# AQUALLIANCE

April 10, 2024

Re: Revised Corning Subbasin Groundwater Sustainability Plan

Figure 1. Subsidence in Agricultural Lands Within the Corning Subbasin (5-021.51)

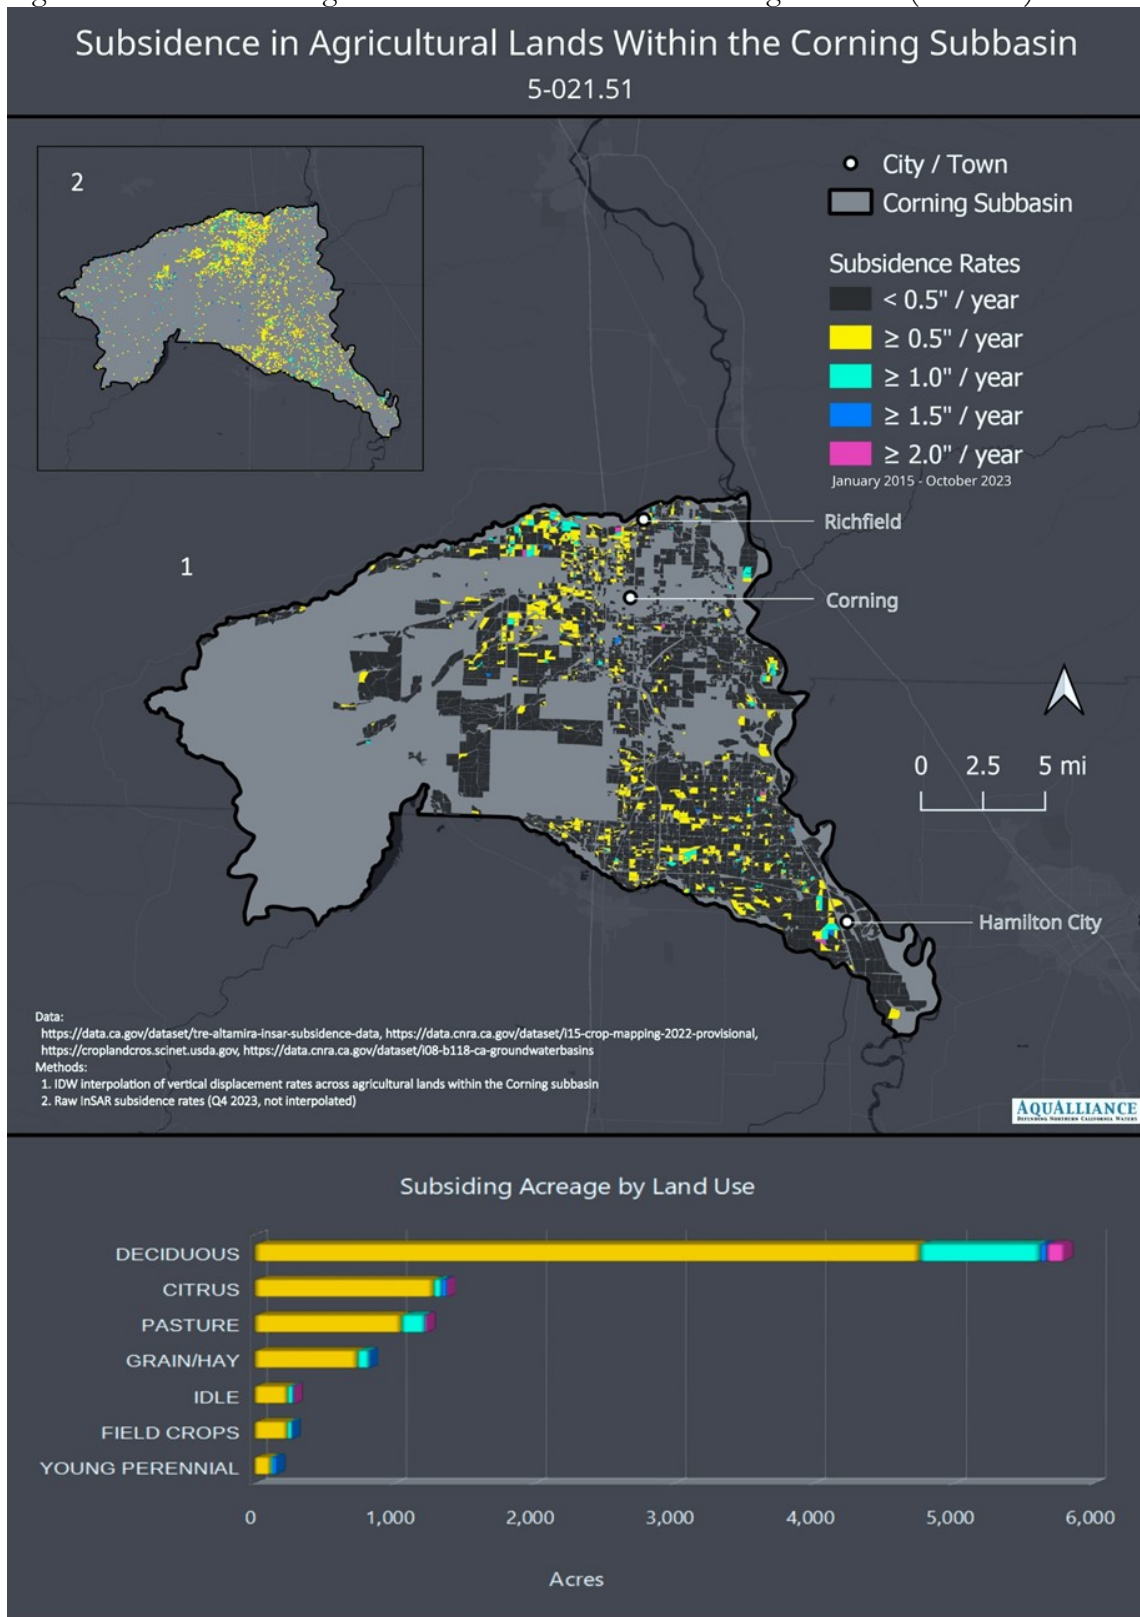
It appears the revised GSP didn't change anything regarding subsidence. While the issue wasn't raised in DWR's determination letter, unfortunately, the GSA had an opportunity to look at a growing body of evidence that could have better advised the GSA, residents, and farmers regarding the seriousness of subsidence in the Corning Subbasin. The revised GSP contains a conclusion that we strongly disagree with: "There are no data gaps identified for the land subsidence sustainability indicator at this time, since existing data sources provide sufficient information at a scale that is appropriate for the GSP implementation."<sup>3</sup> Figure 1 indicates that **there is widespread inelastic subsidence occurring in the Corning Subbasin.**<sup>4</sup> There is a significant area with subsidence taking place greater than 0.5 inch per year. Based on the InSAR data from 2015-2023, there are scattered areas with subsidence greater than 1-2 inches per year that likely exceed the current MT of half a foot per year over five years. These data are not disclosed in the Corning Subbasin GSPs released to date or the Annual Report for 2023 that was just submitted to DWR in April 2024.

The revised GSP goes on to assert that "Available data indicate that little to no inelastic subsidence has occurred in the Subbasin during the past 2 decades."<sup>5</sup> Really? The publicly available data used in Figure 1 demonstrate otherwise.
